Recovery Center
Vinita (Craig County), Oklahoma

ADDENDUM 01

PROJECT: Cherokee Nation of Oklahoma
Vinita Recovery Center

PROJECT #: 25-08.71

SHEET NUMBER: **L0.01**

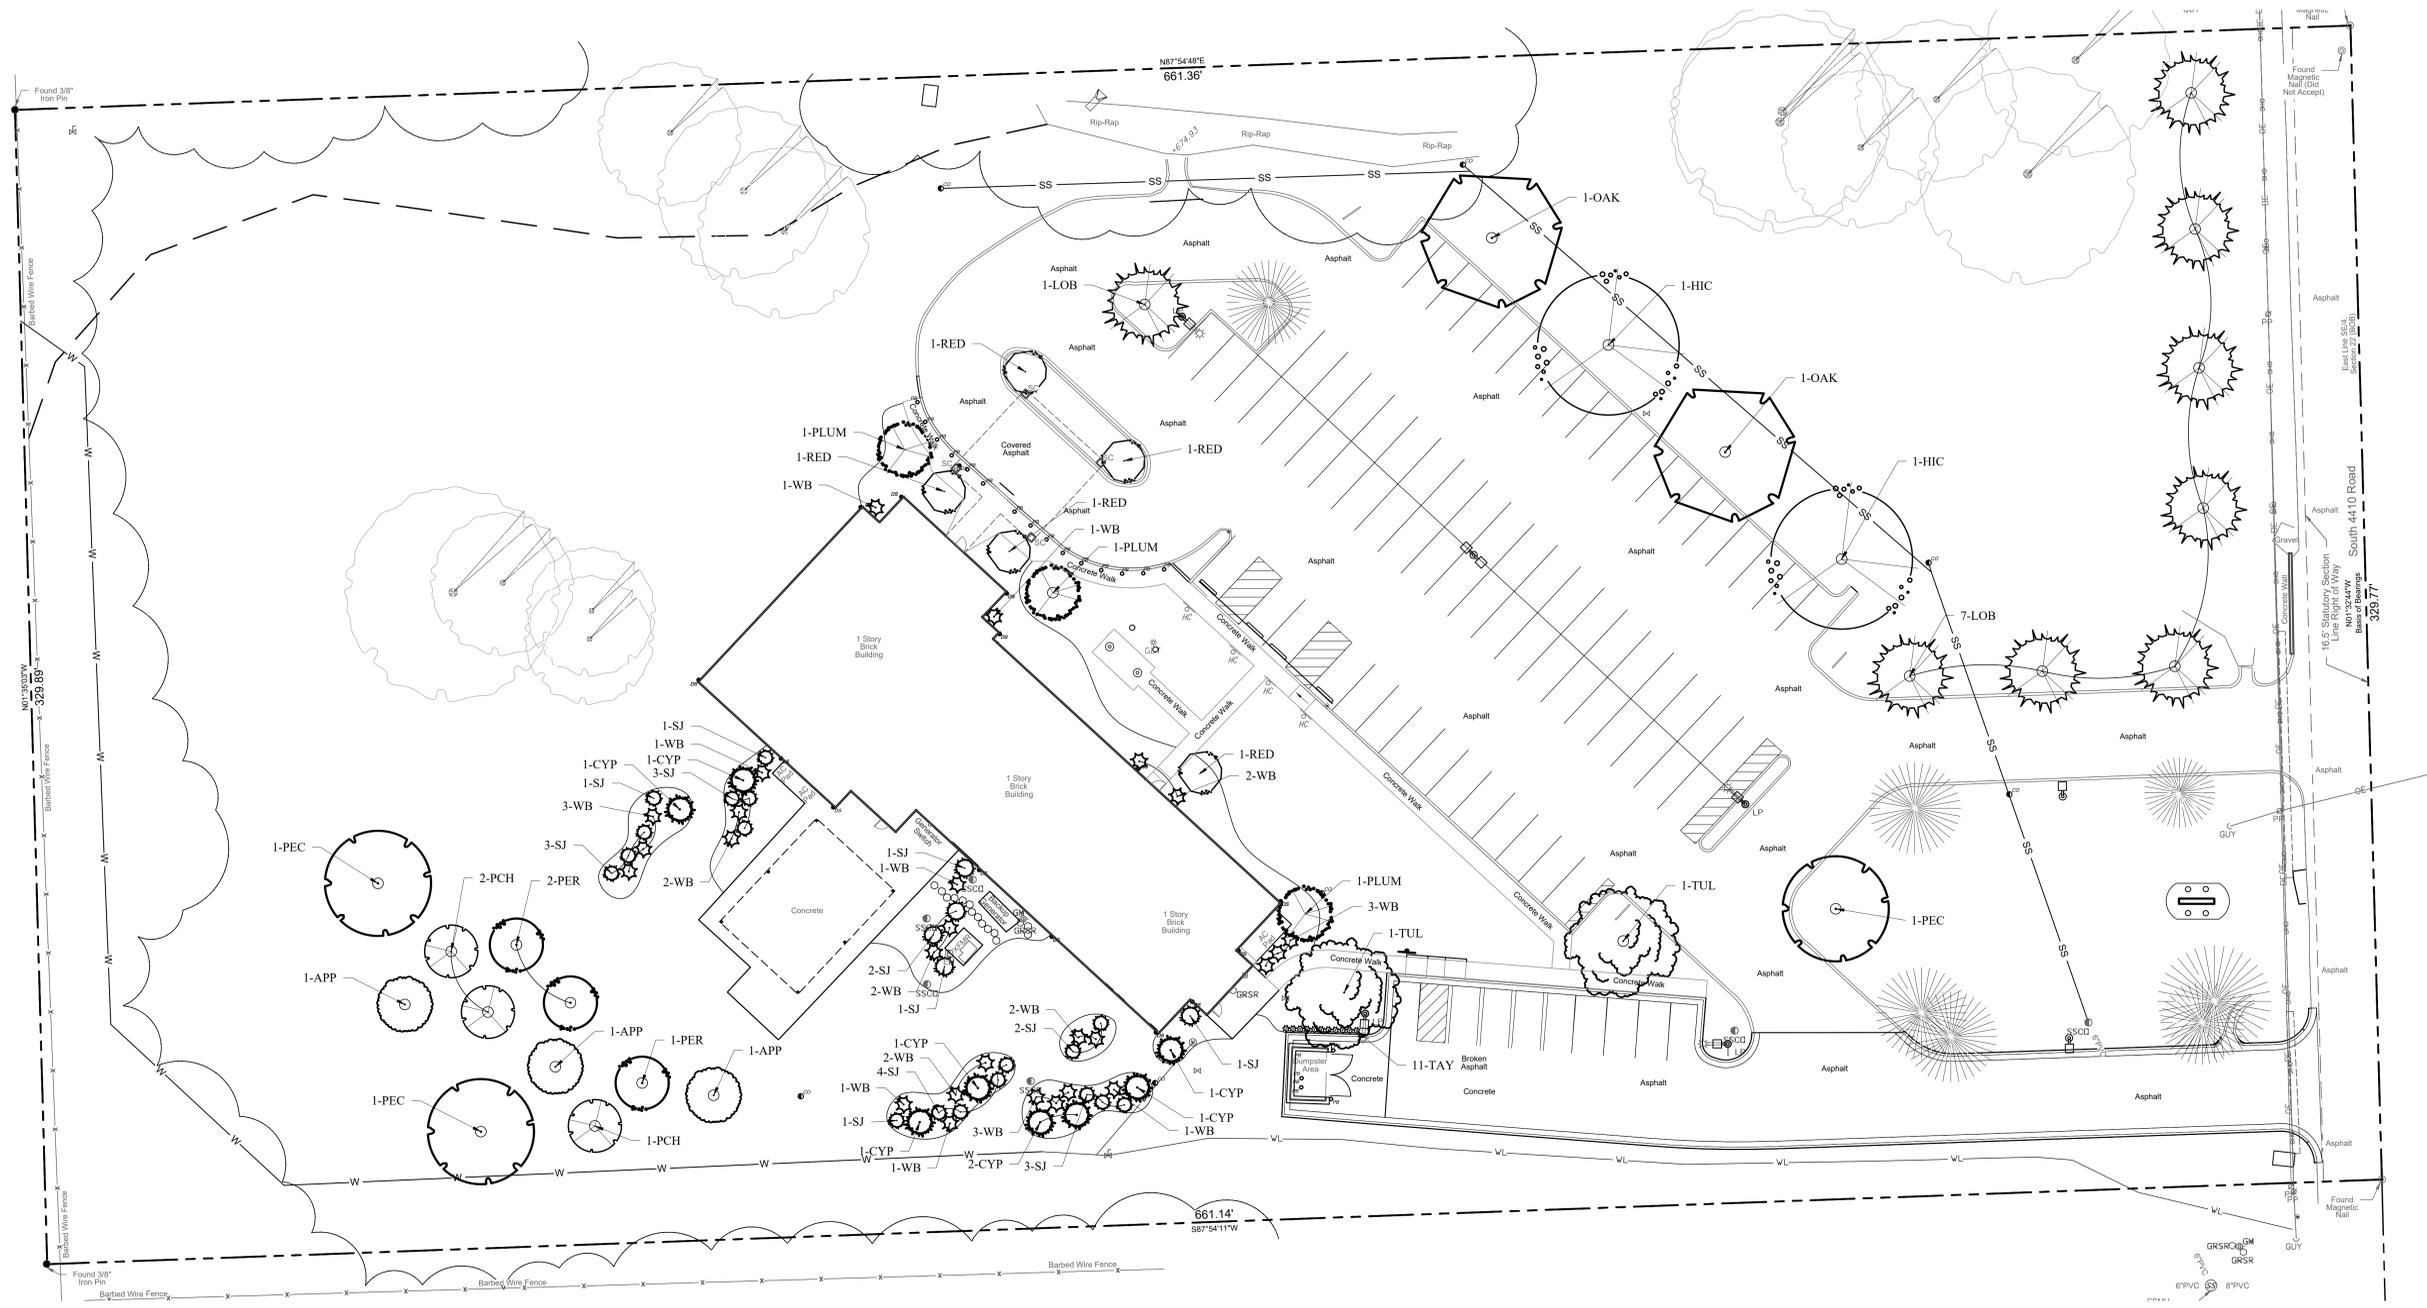
3. Reference Sheet L0.01 IRRIGATION NOTES (sheet reissued)
 - a. Turned off Civil underground utilities background
4. Reference Sheet L0.02 SITE PLAN (sheet reissued)
 - a. Turned off Civil underground utilities background
5. Reference Sheet L0.04 TREE PLANTING PLAN (sheet reissued)
 - b. Turned off Civil underground utilities background

E0.01

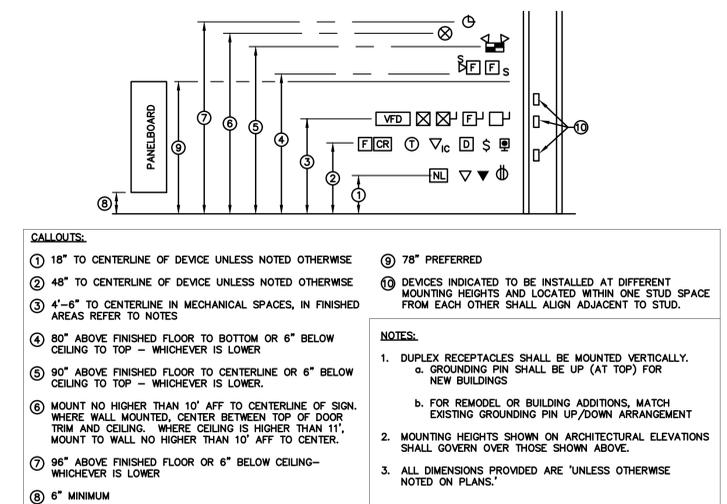
8. Reference Sheet E0.01 GERNAL ELECTRICAL NOTES, LEGENDS AND SCHEDULES (sheet reissued)
 - a. Revised fixture schedule as follows:
 - i. Type B changed to field selectable strip
 - ii. Type D added lumen package L31
 - iii. Type N changed to surface mount
 - iv. Type SW added lumen package C
9. Reference Sheet E2.02 PARTIAL ELECTRICAL LIGHTING PLAN (sheet reissued)
 - a. Changes switch for dosing window fixtures to dimming.

4. Type N fixture shall be surface mounted.
5. Type D fixture shall be 3100 lumens.
6. Type B fixture is changed to HE Williams FS-4-LS-8-CS
7. Type SW fixture to have 600mA drive current.
